Project Name: UHN – Lab Histology Ventilation Upgrade
Project Number: 115625050

3.0 DRAWINGS

End of Addendum No. 2

GROUND FLOOR - HISTOLOGY SCOPE OF WORK PLAN

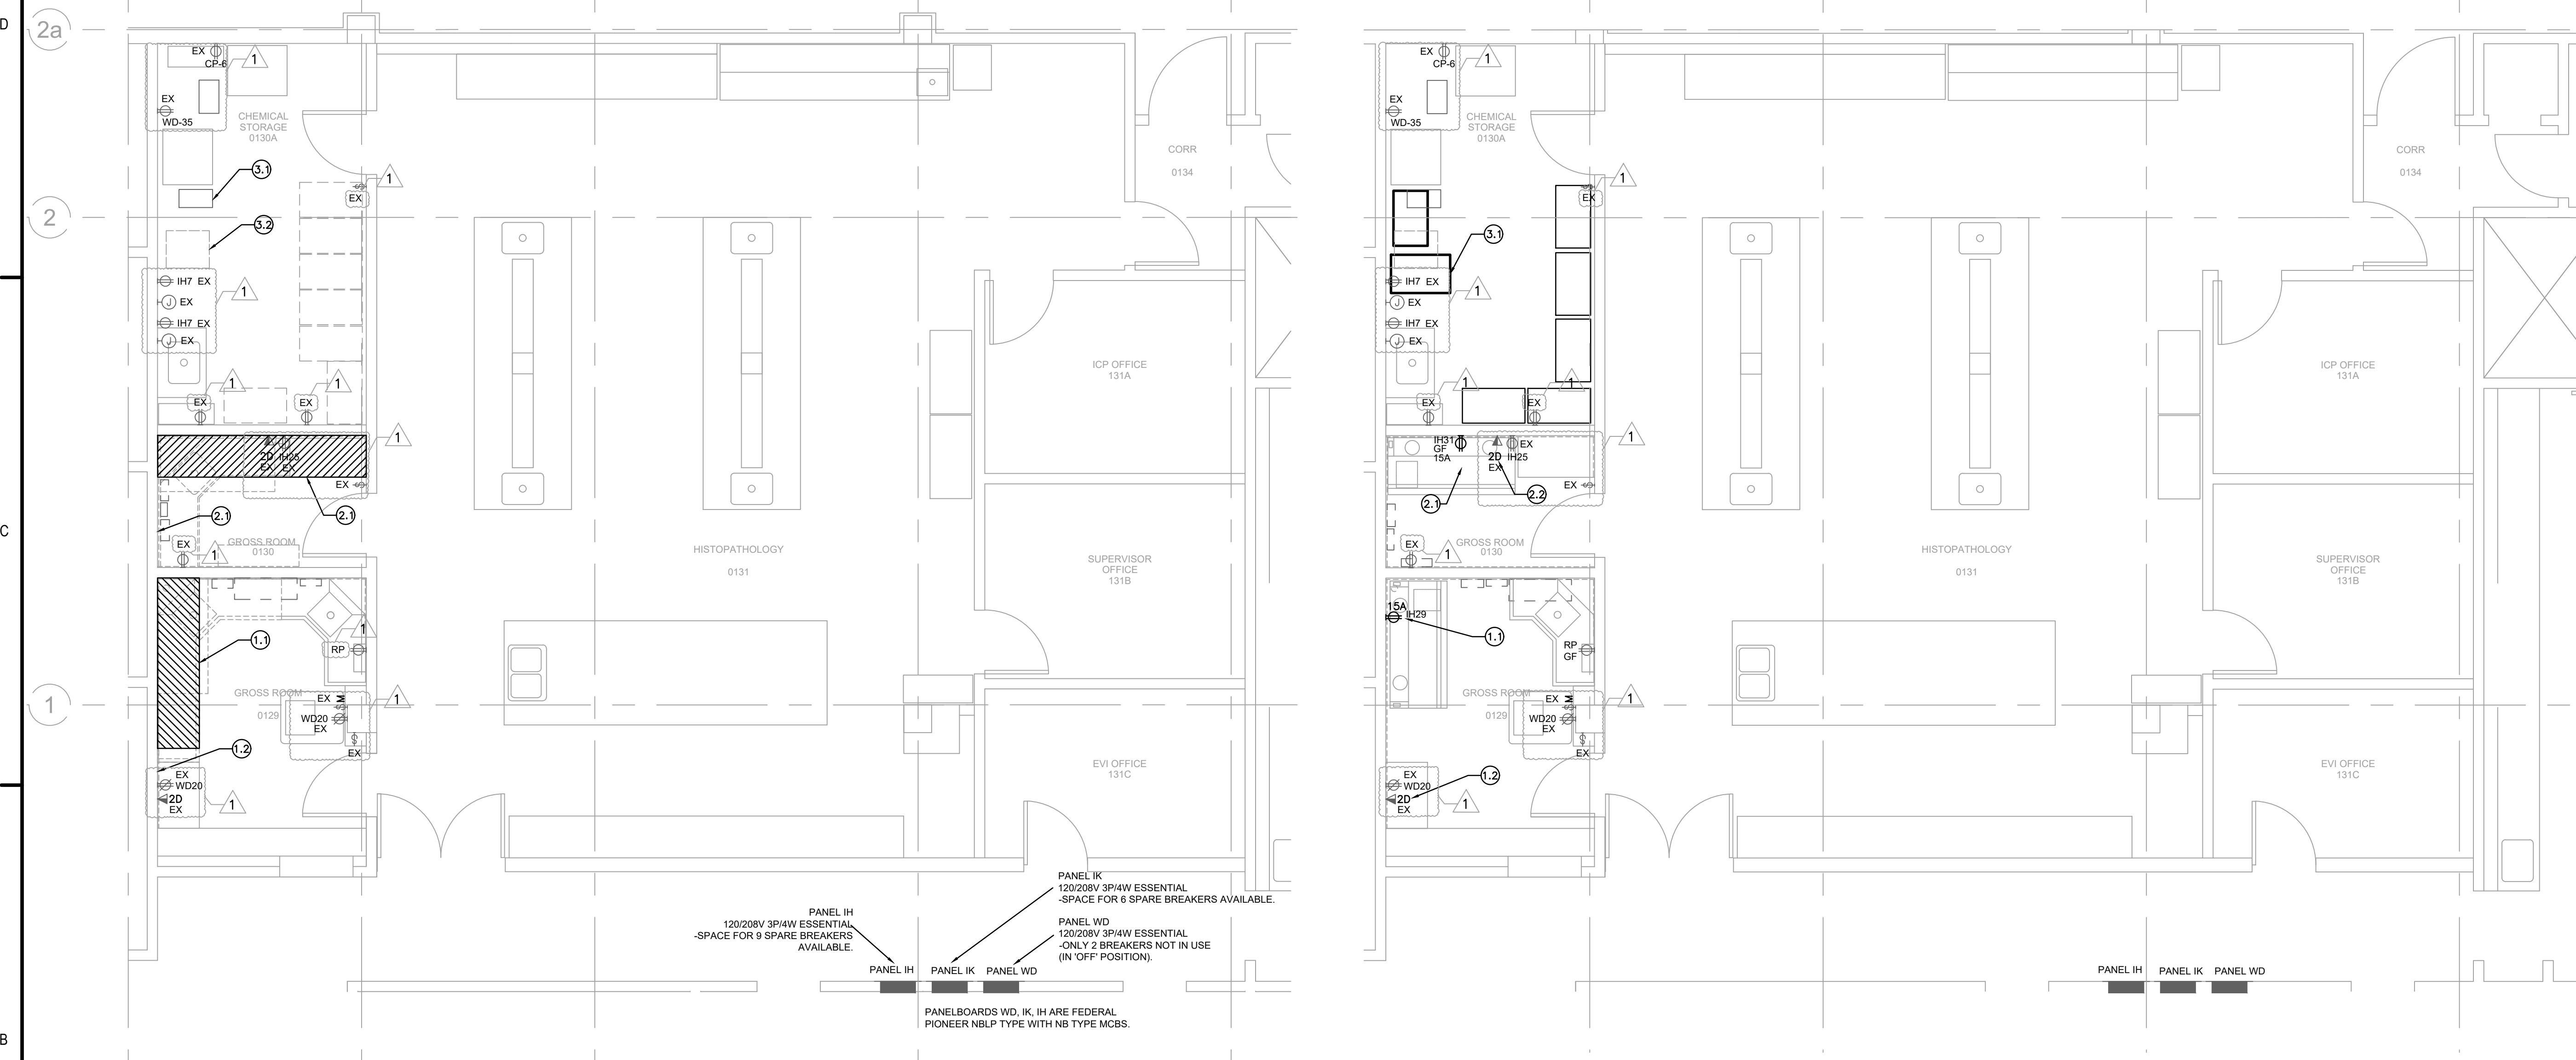
Question: On drawings E-101 and E-102 renovation plans, the majority of electrical devices show the abbreviation ER which as per E-000 is Existing device in relocated position. But the devices are shown in the same location as on the demolition drawings. Please confirm that it is anticipated that each device showing an ER is to be relocated?

Answer: This is an error on the drawings. Please find attached revised drawings E101, E102 and E111. The drawings are updated to reflect that the items that are to remain in the existing location are shown with abbreviation "EX".

GROUND FLOOR -
HISTOLOGY LIGHTING PLAN

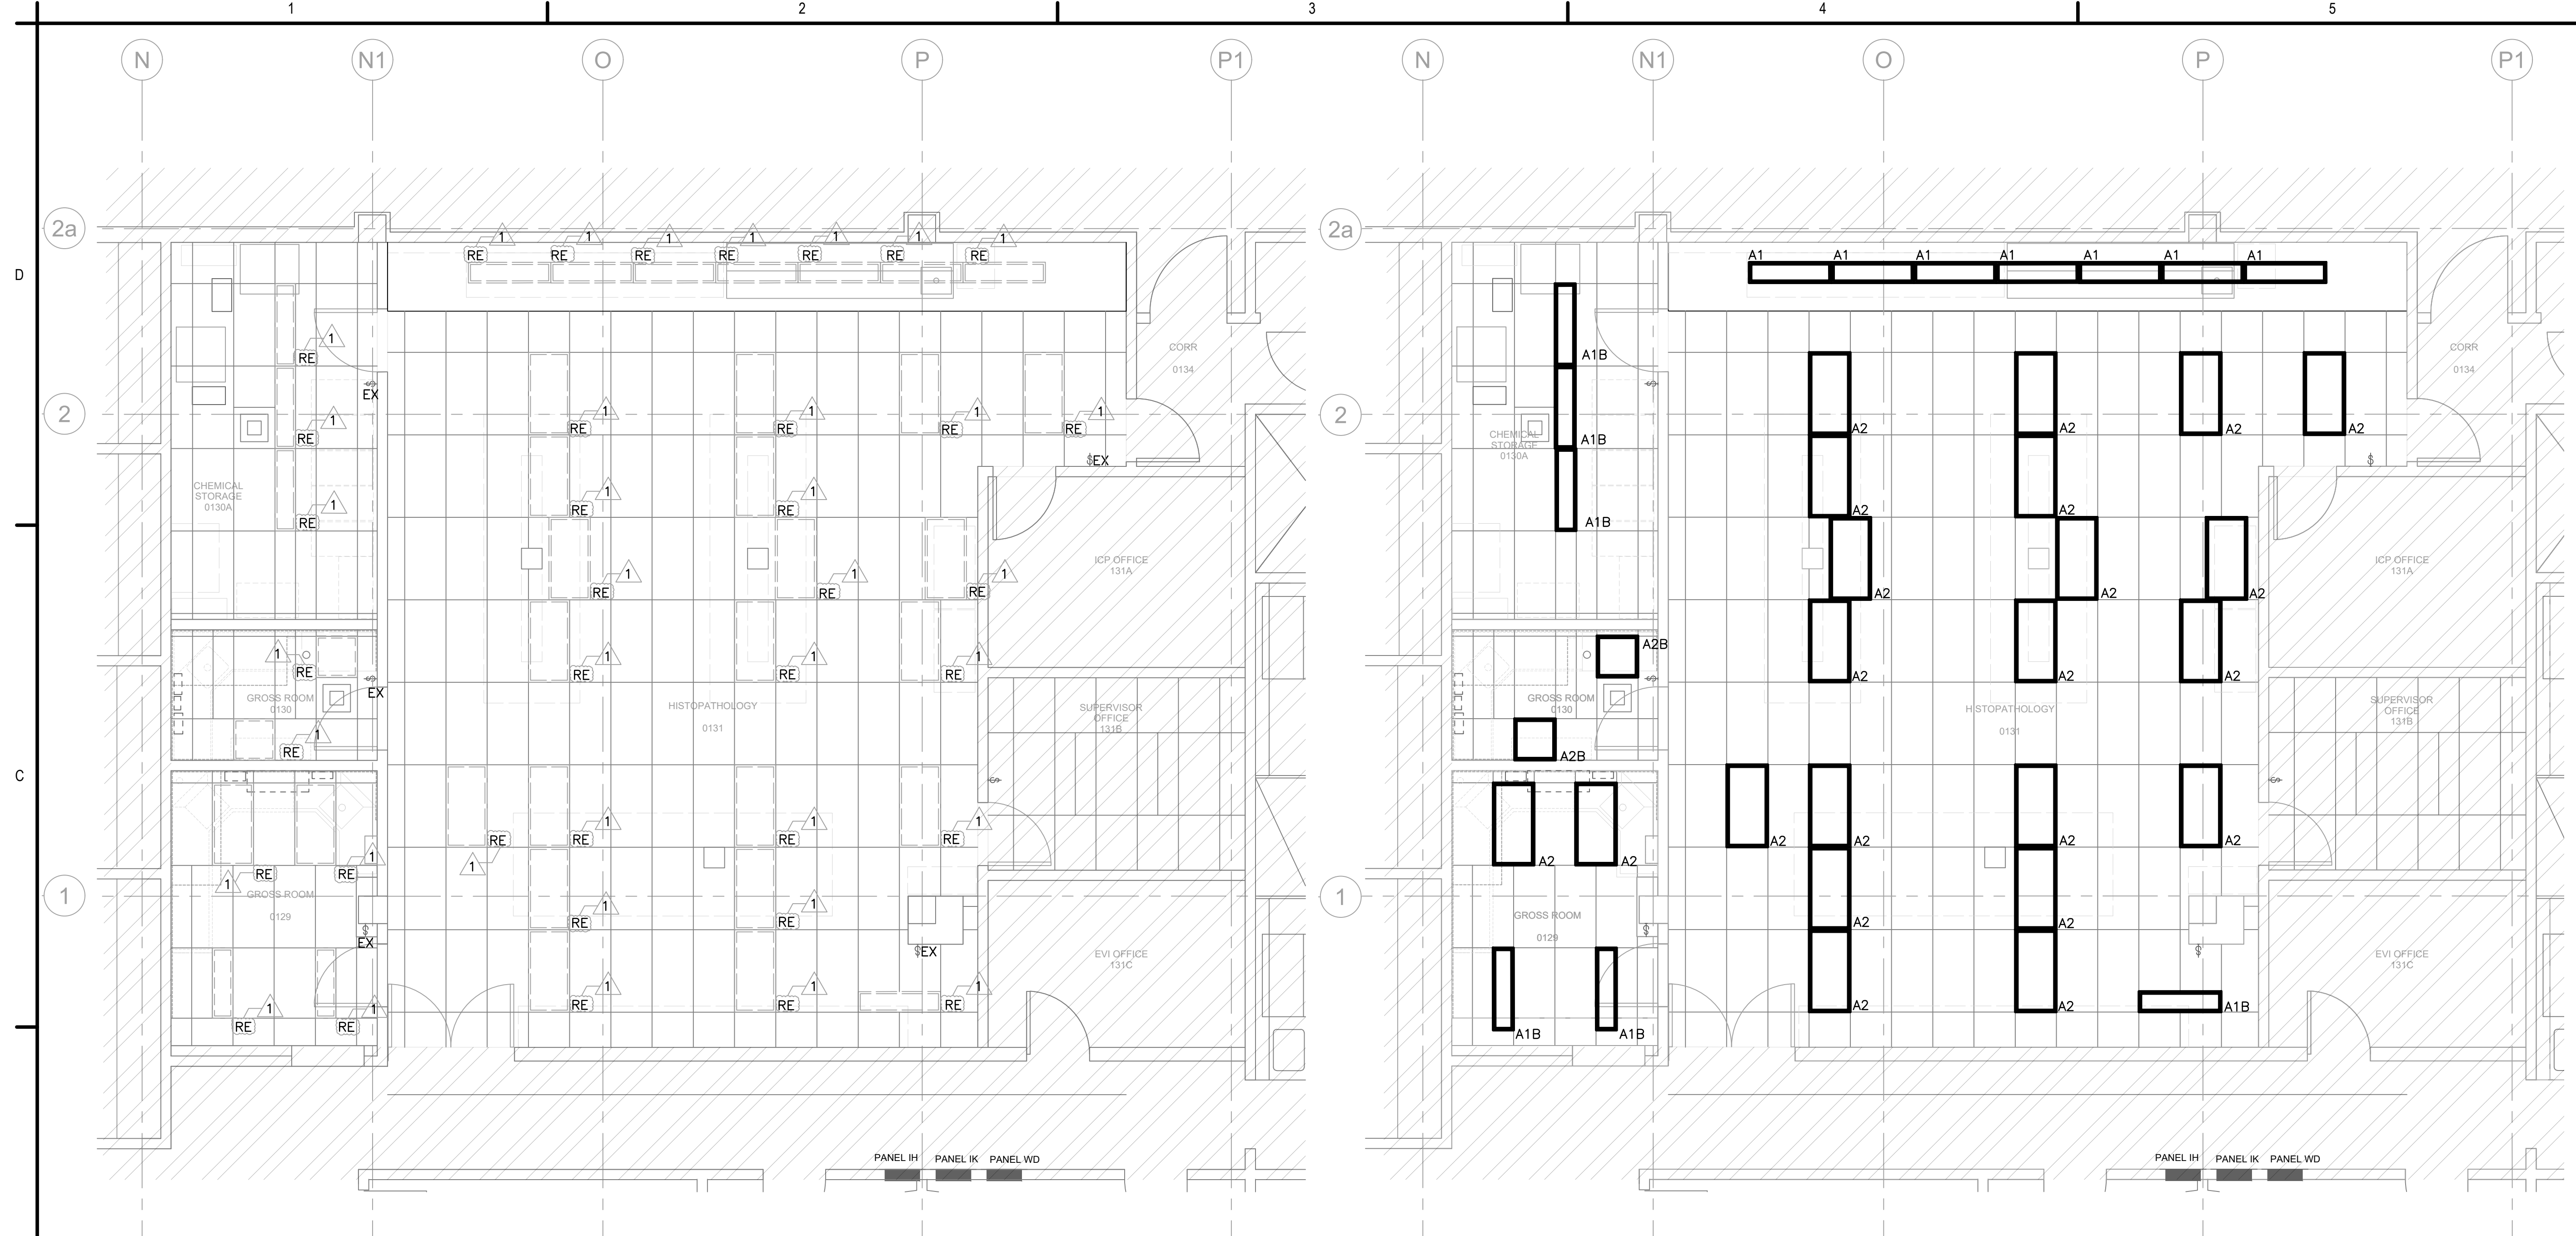
Question: Light Type A1 shows to be drywall recessed. Please confirm that there is existing drywall kits that the new A1 fixtures can drop into or if new drywall kits are required?

Drawing E-111 Fixture Schedule appears to be sole sourced. Will the following be acceptable alternatives: Type A1 Lithonia CPX 1X4 4000LM 40K M4 or RAB PANEL1X4-40 or Philips Day-Brite FBX14L40-4K, Type A2 Lithonia CPX 2X4 5000LM 40K M4 or RAB PANEL2X4-50 or Philips Day-Brite FBX24L50-4K, Type A1B Lithonia CPX 1X4 4000LM 40K M4 or RAB PANEL1X4-40 or Philips Day-Brite FBX14L40-4K, Type A2B Lithonia CPX 2X2 4000LM 40K M4 or RAB PANEL2X2-40 or Philips Day-Brite FBX22L40-4K

Answer: We do not expect the existing drywall kits to be reused. Allow for new drywall kits.

Answer: Refer to table below for acceptable manufacturers and catalogue numbers:

Type	Description	Mounting	Acceptable alternative #1	Acceptable alternative #2
A1	1x4 backlit panel, recessed	Drywall recessed	Lithonia Lighting CPX 1X4 AL07 SWW7 M4	RAB Design CPL14-LED30A18-B-VK
A2	2x4 backlit panel, recessed	T-bar recessed	Lithonia Lighting CPS 2X4 AL08 SWW7 M2	RAB Design CPL24-LED45A30-B-VK
A1B	1x4 backlit panel, recessed	T-bar recessed	Lithonia Lighting CPX 1X4 AL07 SWW7 M4	RAB Design CPL14-LED30A18-B-VK
A2B	2x2 backlit panel, recessed	T-bar recessed	Lithonia Lighting CPX 2X2 AL07 SWW7 M4	RAB Design CPL22-LED30A18-B-VK
